Appl. No. 10/718,301
Amdt. dated 10/12/2005
Reply to Office Action of 07/12/2005

CA920030063US1

FIG. 2

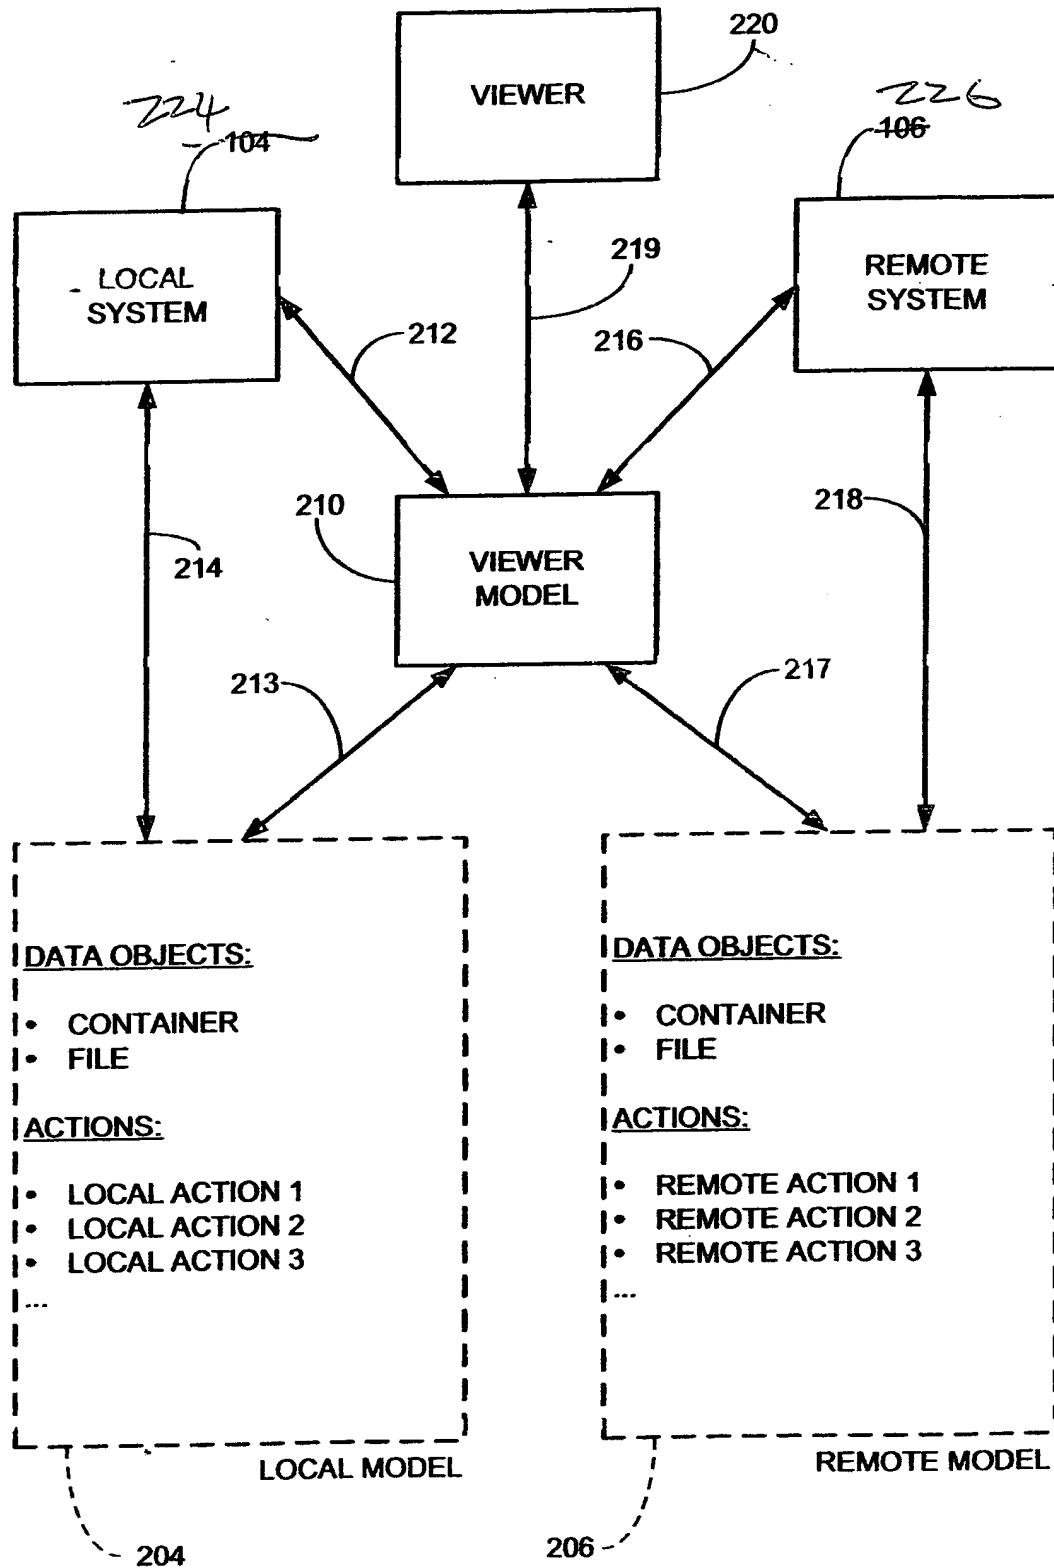
Please replace reference numerals 104 and 106 with reference numerals 224 and 226, respectively, and as shown in RED in the attached corrected Drawing figure.

Fig. 2 has been amended to replace reference numerals 104 and 106 with reference numerals 224 and 226, respectively.
